STAFF RECOMMENDATION

1609 Douglas Avenue

August 18, 2021

Application: New Construction-Materials; Violation/Show Cause

Sheet Number
A.1

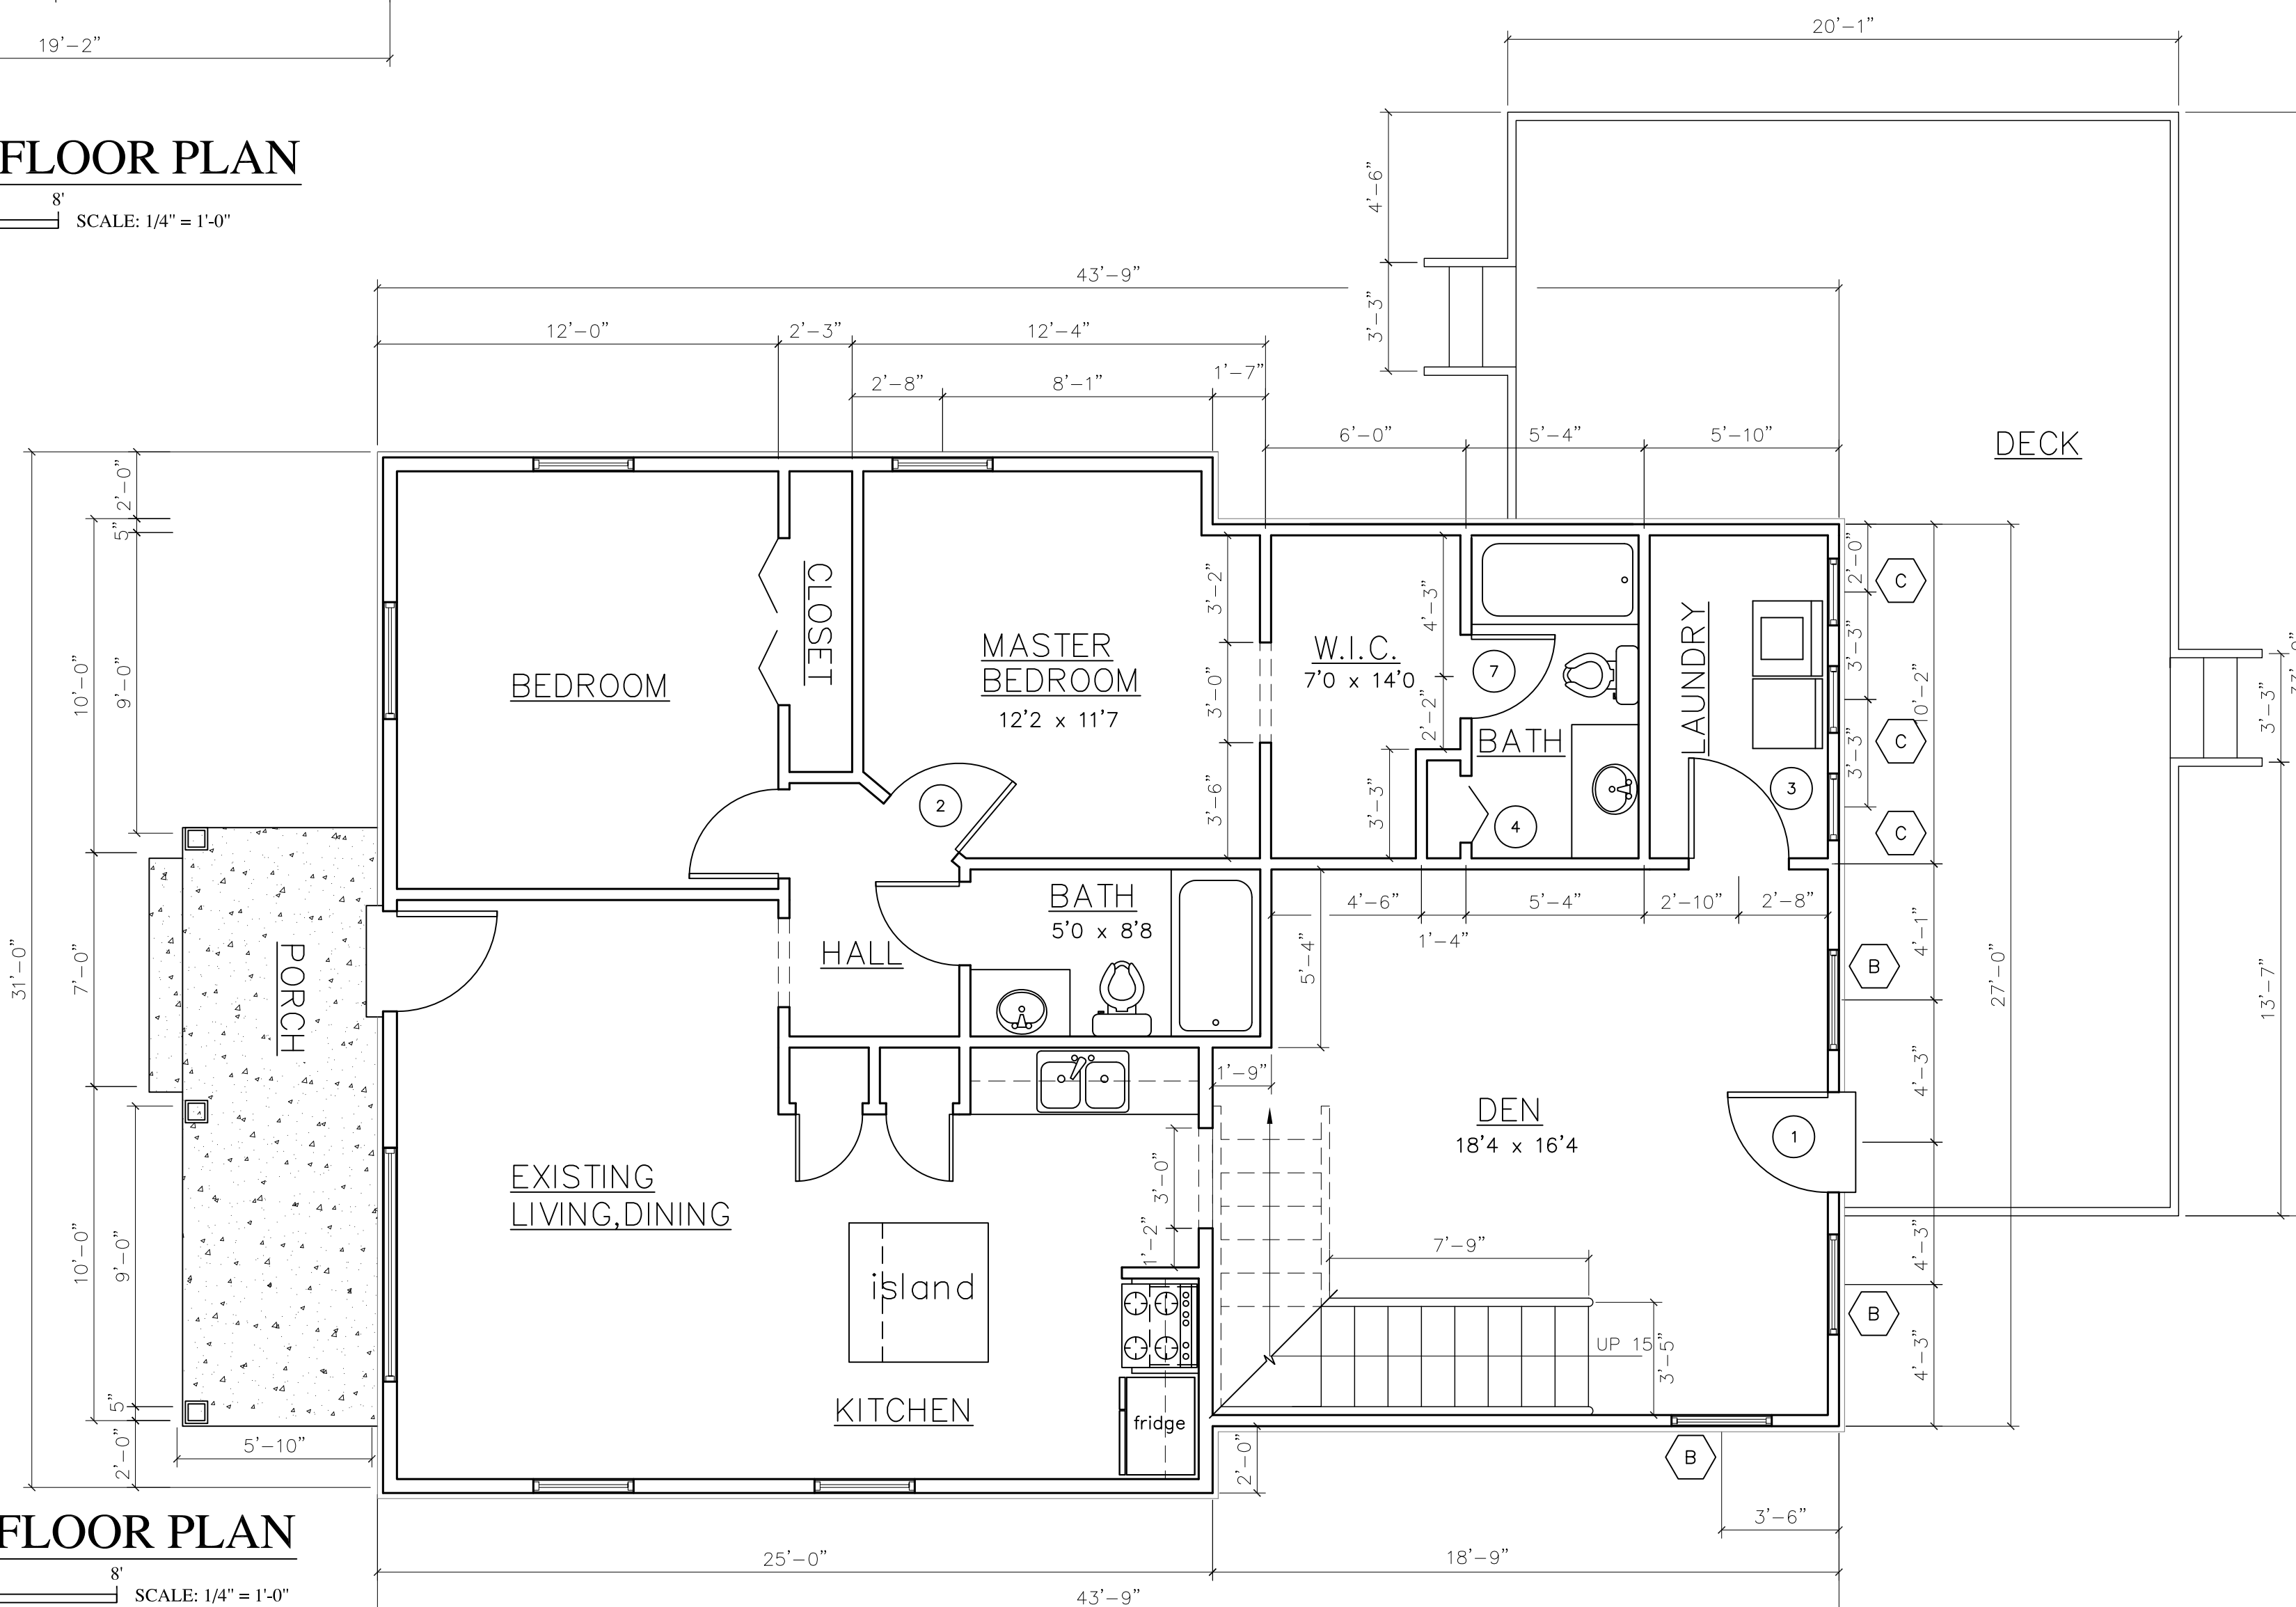
When approved, the rear addition was inset two feet on either side, conforming to Guideline IV(B)(2). The rear addition, as it was built, sits flush with the existing walls, but it does not extend past the existing footprint. The addition is also just over fourteen feet (14') feet longer than what was originally permitted. This may be appropriate since the building is non-contributing; however, more information is needed, specifically as-built drawings and a site plan, in order to analyze whether or not the building fits into the historic context in terms of footprint and setbacks.
